JAYNE'S PROPERTY SKETCH PLAN

LETTER OF INTENT

AUGUST 2022

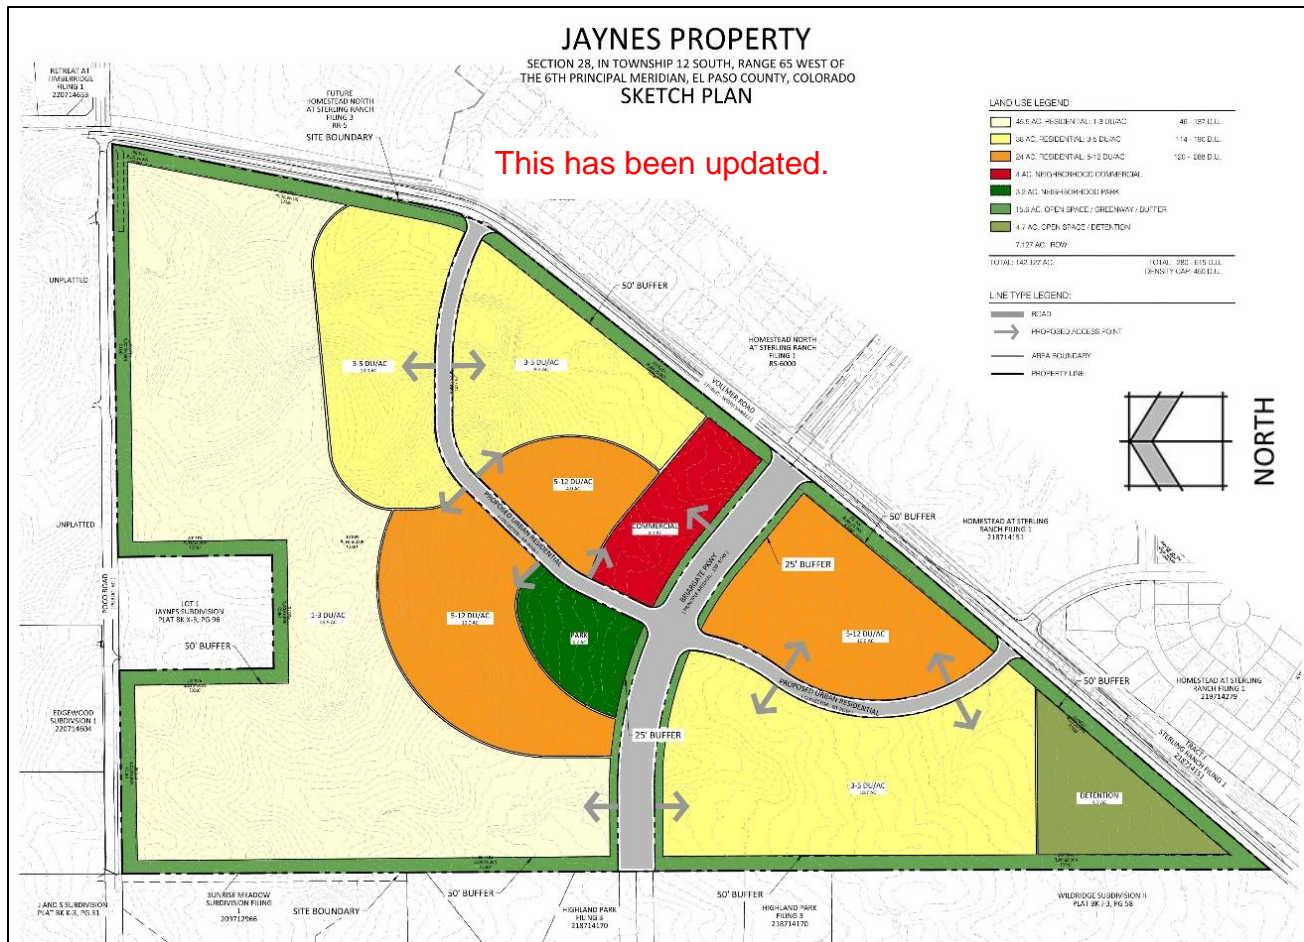
please match checklist and see planning comments on SKP for categories and density ranges; no MF is proposed?

Table has been updated to match updated SKP plan. Density type has been added.

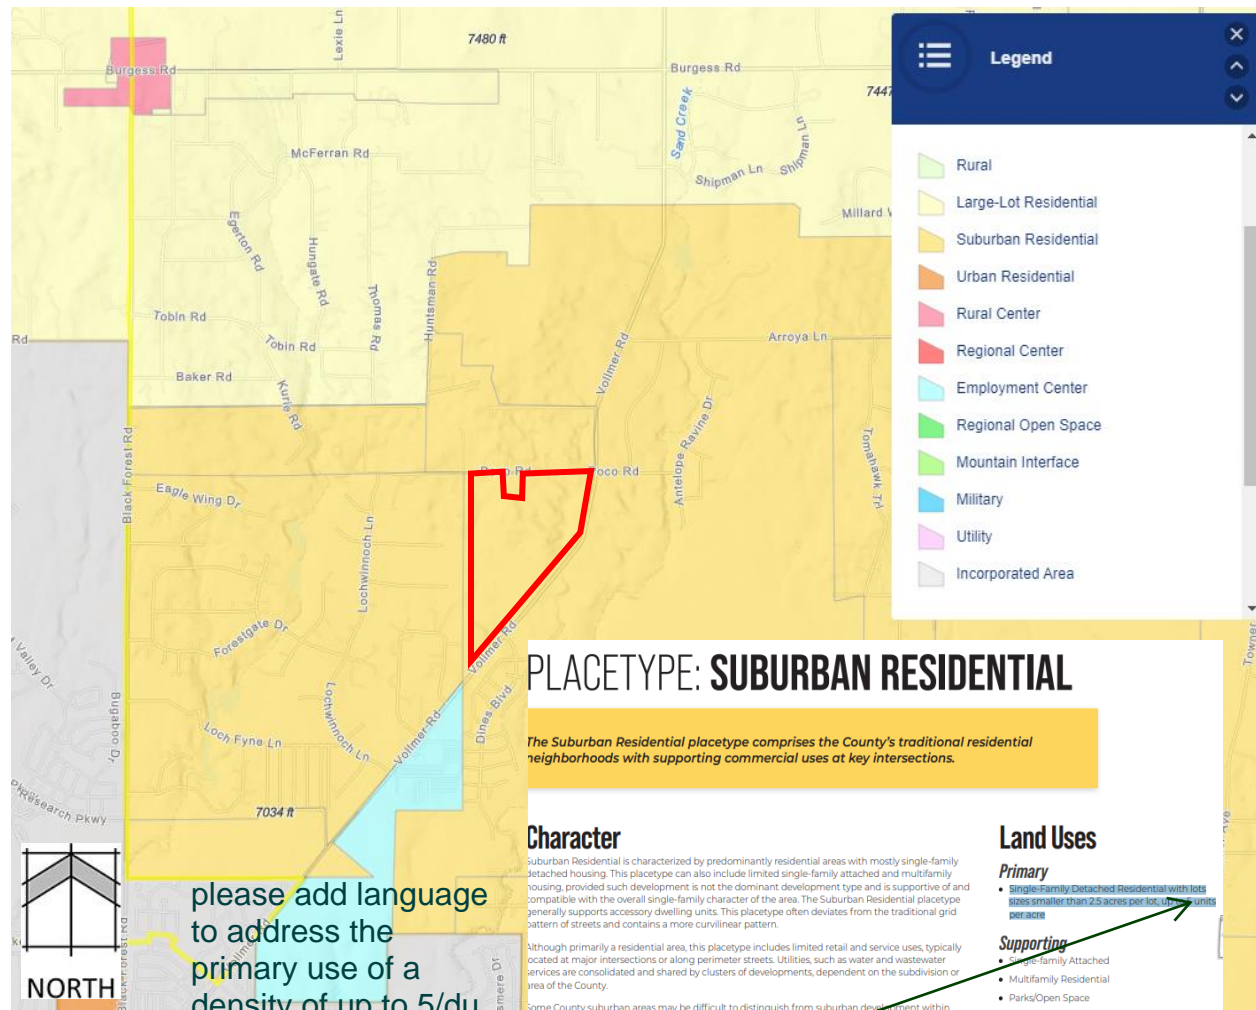
A 5.5AC park is proposed where the existing wetlands are shown.

Wetland areas that are not waters of the US still should be preserved; is there some areas to be protected while others will be mitigated?

"G) Preservation of Natural Landscape. The primary importance of the preservation and enhancement of the natural landscape and vegetation shall be considered. The layout and design of lots, blocks, and rights-of-way shall provide desirable settings for structures by making use of natural features, unique or distinctive topographic features including buttes and rock outcroppings; existing vegetation; drainage; riparian and wetland areas; significant wildlife habitats; identified aquifer recharge areas; and aesthetic features. Alteration of features shall be kept to a minimum and shall be based on practical engineering considerations."

A 5.5AC park is proposed where the existing wetlands are shown. The intent of the park is preserve the wetland and existing ponderosa pines.
